Access Compliance Report Public Rights-of-Way (Curb Ramps)

Main Street: ABELIA_ST Cross Street: S_SELLAS_RD Location: NE

ADA ID: RPAT211102141058 Ramp Type: Type 1 - Perpendicular Diagonal Initial Pass/Fail: Fail Overall Compliance: No Severity Score: 2

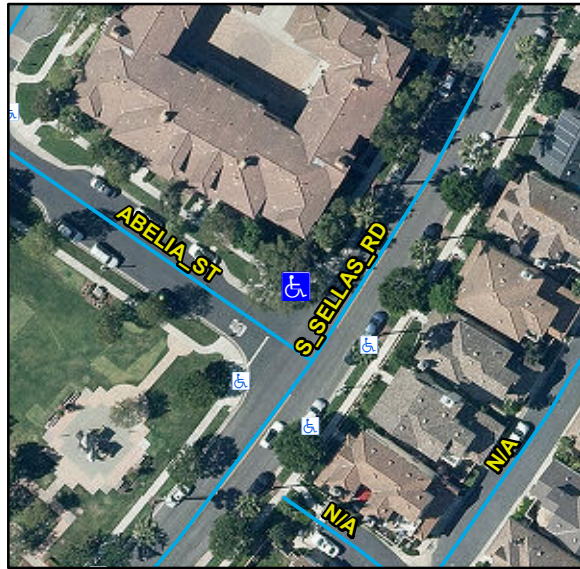
Compliance	Description	Data	Compliance	Description	Data
N/A	Ramp Length (in)	88	N/A	Flare Type LT	
Yes	Ramp Width (in)	48			N/A
Yes	Ramp Run Slope (%)	2.5	N/A	Flare Slope LT (%)	N/A
No	Ramp Cross Slope (%)	2.4	N/A	Flare Traversable LT	N/A
N/A	Landing Present	N/A	N/A	Flare Type RT	
N/A	Landing Length (in)	N/A			N/A
N/A	Landing Width (in)	N/A	N/A	Flare Slope RT (%)	N/A
N/A	Landing Run Slope (%)	N/A	N/A	Flare Traversable RT	N/A
N/A	Landing Cross Slope (%)	N/A	N/A	DWS Provided	N/A
N/A	Landing Movement Obstructed?	N/A	N/A	DWS Contrast	N/A
	Landing Movement Type	N/A	N/A	DWS Length (in)	N/A
N/A	Landing Shared	N/A	N/A	DWS Full Width	N/A
N/A	Clear Space	Yes	N/A	DWS Offset Left (in)	N/A
N/A	Clear Space To Crosswalk (in)	N/A	N/A	DWS Offset Right (in)	N/A
N/A	Marked Crosswalk 1	No	N/A	Marked Crosswalk 2	No
	Crossing 1 Direction	SW		Crossing 2 Direction	SE
	Marked Crosswalk 1 Width (in)	N/A		Marked Crosswalk 2 Width (in)	N/A

N/A	Ramp Inside Crosswalk 1	N/A	Yes	Ramp Inside Crosswalk 2	N/A
	Crossing 1 Slope (%)	0.5		Crossing 2 Slope (%)	1.8
	Crossing 1 Cross Slope (%)	0.4		Crossing 2 Cross Slope (%)	0.6
N/A	Gutter Ponding	N/A	No	Curb Slope	7.4
Yes	Gutter Lip Height (in)	0		Road Run Slope (%)	0.4
N/A	Gutter Run Slope (%)	N/A		Road Cross Slope (%)	0.1
N/A	Gutter Cross Slope (%)	N/A			
Yes	Overall Surface Condition: Acceptable		No	Perp Joint Present	No
	Cross Gutter Present?	No		Spandrel Present?	No
	Replace Cross Gutter?	N/A		Replace Spandrel?	N/A

Remove & Replace Curb Ramp With Two New Directional Ramps or Equivalent.

R304.2.2, R204.3, R304.5.3, STD 1115
